CVHE-SB-15

SUBJECT: "STARTER-FAULT" BREAKER/K10 RELAY RACE (CVHEs OF "A" THRU "J" DESIGNS)

Figure 1
 Typical Electrical Schematic
 for CVHE Units w/Electronic
 Capacity Control
 ("F" thru "J" Designs Shown)

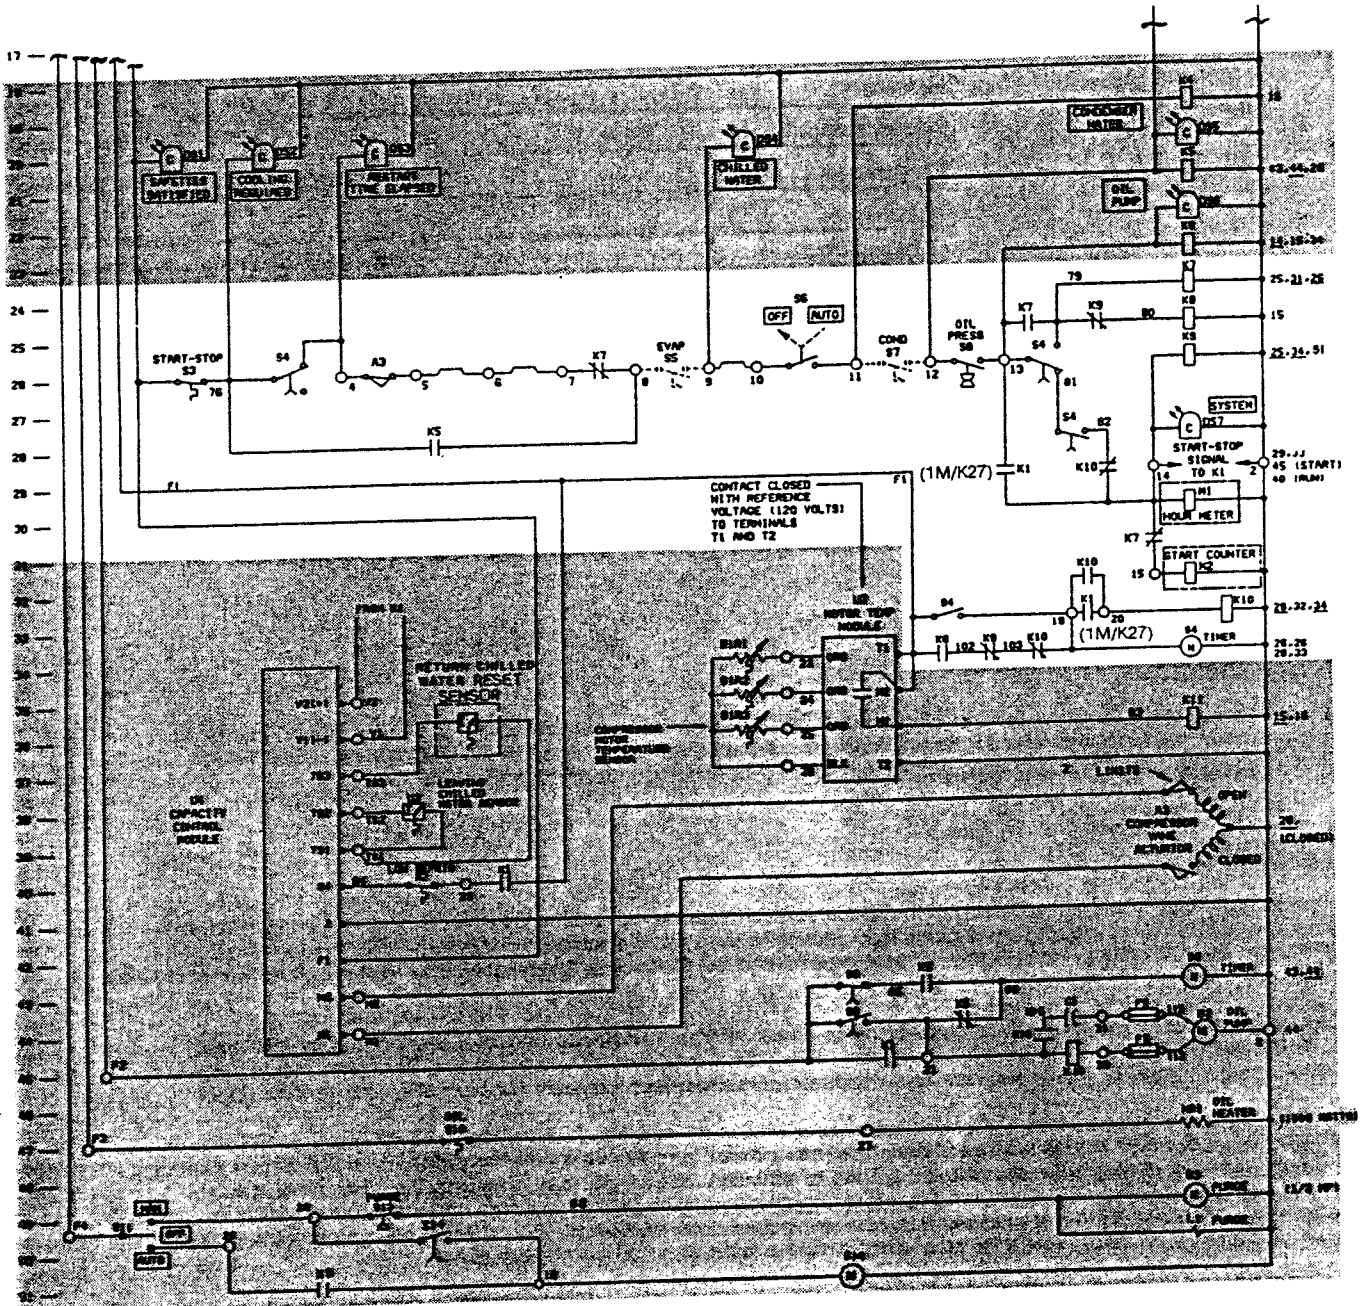
Ordinarily, a normal "start" signal from Terminal 14 of the unit control panel energizes the 1M (K27) contactor which, in turn, closes 2 sets of normally-open auxiliary contacts. (Refer to the typical electrical schematic in Figure 1.) The auxiliary contacts located between Wires 13 and 14 (Lines 26 and 29) close first, followed by those located between Wires 19 and 20 (Line 33).

Notice that closure of the auxiliary contacts between Wires 13 and 14 establishes a "holding" circuit for the "start" signal before the contacts between Wires 19 and 20 can close. This sequence of events assures that the "start" signal is not interrupted when the K10 relay energizes and opens its normally-closed contacts between Wires 82 and 14 (Line 29).

Let's look at what would happen if the contact closure sequence were reversed. Once the inhibit circuit (Line 26) is satisfied (i.e., evaporator and condenser water flows are proven, and oil pressure is established), a "start" signal is sent to the starter panel through the normally-closed set of K10 contacts. If the K10 relay energizes (via closure of the auxiliary contacts between Wires 19 and 20) before the "holding" circuit is established, the starter energizes—but only momentarily. As soon as the normally-closed K10 contacts between Wires 82 and 14 open, the starter panel drops out of the circuit, and the unit control panel's "starter fault" circuit breaker trips 15 to 20 seconds later.

1. Establish the correct wiring sequence for Wires 13 and 14, and Wires 19 and 20.

Ensure that Wires 13 and 14 are connected to a set of normally-open, auxiliary contacts on the 1M (K27) contactor; contacts selected for this purpose should be located as close to the auxiliary-contact actuator as possible (i.e., the auxiliary switch located nearest the starter back panel). Then, connect Wires 19 and 20 to a set of normally-open auxiliary contacts located farther out on the auxiliary contact stack.

This wiring arrangement encourages establishment of the "holding" circuit before the normally-closed contacts of the K10 relay can open.

Figure 2
Addition of a 0.3-Second
Time Delay Relay to the
K10 Relay Circuit

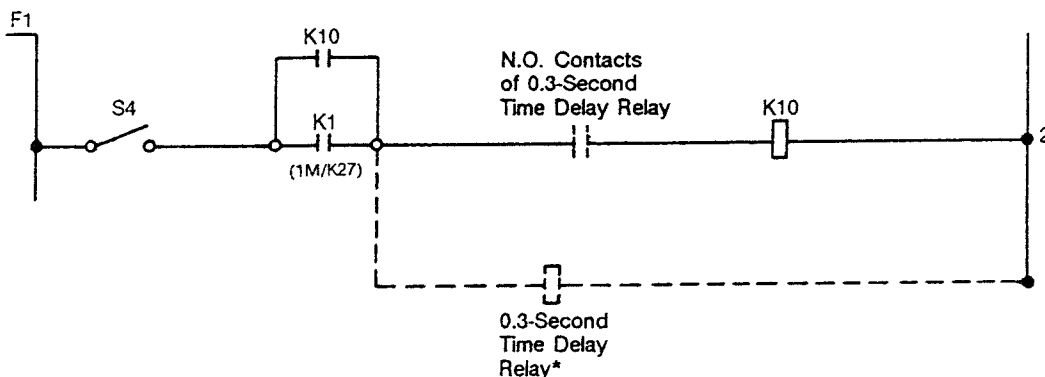
2. Add a 0.3-second time delay relay to the K10 relay circuit.

Connect the normally-open contacts of 0.3-second time delay relay in series with the K10 relay; make sure that the contacts of the time delay relay are installed upstream of the K10 relay coil. Figure 2 illustrates this wiring arrangement.

The addition of this relay postpones the energizing of the K10 relay by 0.3 seconds, thereby assuring that the start signal "holding" circuit is established before the normally-closed K10 contacts open.

*The 0.3-second time delay relay typically used for this purpose is RLY-872.
